TOWN OF OCEAN VIEW PUBLIC NOTICE
PLANNING & ZONING COMMISSION MEETING
January 15, 2026 @ 4:00pm

**RE: Wilkinson Site Plan
Tax Parcel 134-12.00-327.00**

RE: Concept Plan Review – Wilkinson Property (Tax Map ID Map 134-12.00-327.00)

**RE: Preliminary Plan Review – Wilkinson Property
Tax Map ID Map 134-12.00-327.00**

Exhibit B-1. Flooding/ponding visible along fence/edge; water pooled adjacent to property boundary

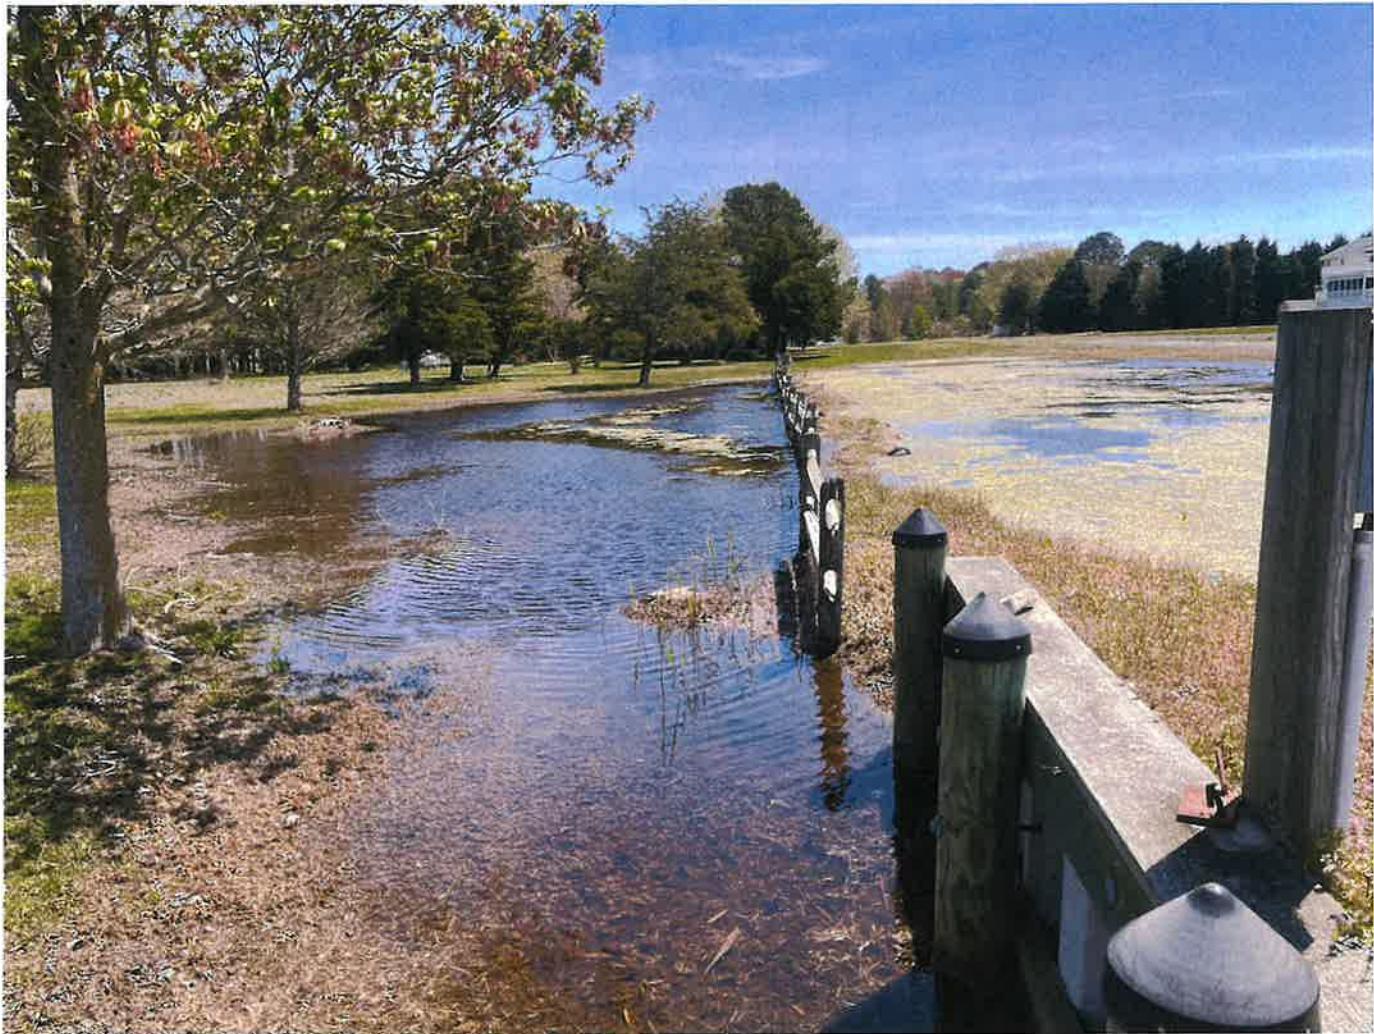
I am not submitting this comment to oppose development. My purpose is to **formally document an ongoing stormwater/drainage issue** impacting my property and to request that any approval under Application P-361 require safeguards so there are **no adverse off-site stormwater impacts to adjoining parcels**, including mine.

1. Requiring an **engineered stormwater management plan** prepared and sealed by a qualified professional, including calculations and design details;
2. Requiring the applicant to demonstrate that **post-development drainage will not worsen off-site impacts** to adjoining parcels (including increased ponding, redirected drainage, or concentrated discharge onto neighboring properties);
3. Requiring defined drainage controls/overflow routing so stormwater does not overtop toward adjoining properties during wet seasons or major rainfall events; and
4. Requiring inspection/enforcement provisions to ensure final grading and stormwater controls are constructed as approved.
